Access Compliance Report Public Rights-of-Way (Curb Ramps)

Intersection ID: 22200 Main Street: S TRYON ST **Cross Street: JOHN PRICE RD** Location: NE

Overall Compliance: No ADA ID: 9D3CB1A59F26 Ramp Type: Perp Initial Pass/Fail: Fail Severity Score: 26.25

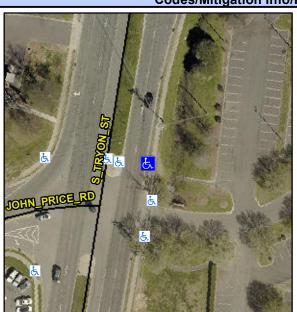
48.0 No

30.0 No

- CO	The Res	PROW/ADA:			N/A	Gutter Ponding?	N/A	N/A	Gutter Slope (%)	N/A
		Not Found, R304.2.2, R304	.5.3		N/A	Gutter Lip Ht (in)	N/A	N/A	Gutter X Slope (%)	N/A
6 m = 1 10 11 11 3		, , , , , , , , , , , , , , , , , , , ,			N/A	Painted X Walk1?	No	N/A	Painted X Walk2?	N/A
						X Walk 1 Direction	To W		X Walk 2 Direction	N/A
					N/A	X Walk 1 Width (in)	N/A	N/A	X Walk 2 Width (in)	N/A
Street 1 Name	S TRYON ST					X Walk 1 Slope (%)	0.7		X Walk 2 Slope (%)	N/A
Stop Condition-Street 2	None					X Walk 1 X Slope (%)	1.0		X Walk 2 X Slope (%)	N/A
Street 2 Name	N/A				N/A	Ramp inside XWalk1?	N/A	N/A	Ramp inside XWalk2?	N/A
Stop Condition-Street 1	N/A					Road Slope (%)	N/A	N/A	Clear Space?	N/A
						Road X Slope (%)	N/A	N/A	Clear Space to XWalk (in)	N/A
					N/A	Any Obstructions?	N/A	N/A	Storm Grate/Utility Hazard?	N/A
		Total Cost:	\$	1850.00		Obstruction Type			Storm Grate/Utility Type	
							N/A			N/A
								Yes	Surface Condition? (G/P)	Good

Possible Solutions:	Compl	iance	Description
Remove & Replace Entire Ramp.	N/A	Ram	p Length (in)
·	Yes	Ram	p Width (in)
	N/A	Flare	Type LT
	N/A	Flare	Slope LT (%)
	N/A	Flare	Traversable LT
	N/A	Land	ing Length (in)
Surveyor Notes:	N/A	Land	ing Width (in)
N/A	N/A	Land	ing Slope (%)
	N/A	Land	ing X Slope (%)
	N/A	Land	ing Curb? (Y/N)
	N/A	Shar	ed Landing?
PROW/ADA:	N/A	Gutte	er Ponding?
Not Found, R304.2.2, R304.5.3	N/A	Gutte	er Lip Ht (in)
	N/A	Paint	ed X Walk1?
		X Wa	lk 1 Direction
	N/A	X Wa	ılk 1 Width (in)
		X Wa	ılk 1 Slope (%)
		X Wa	ılk 1 X Slope (%
	N/A	Ram	p inside XWalk1
		Road	Slope (%)
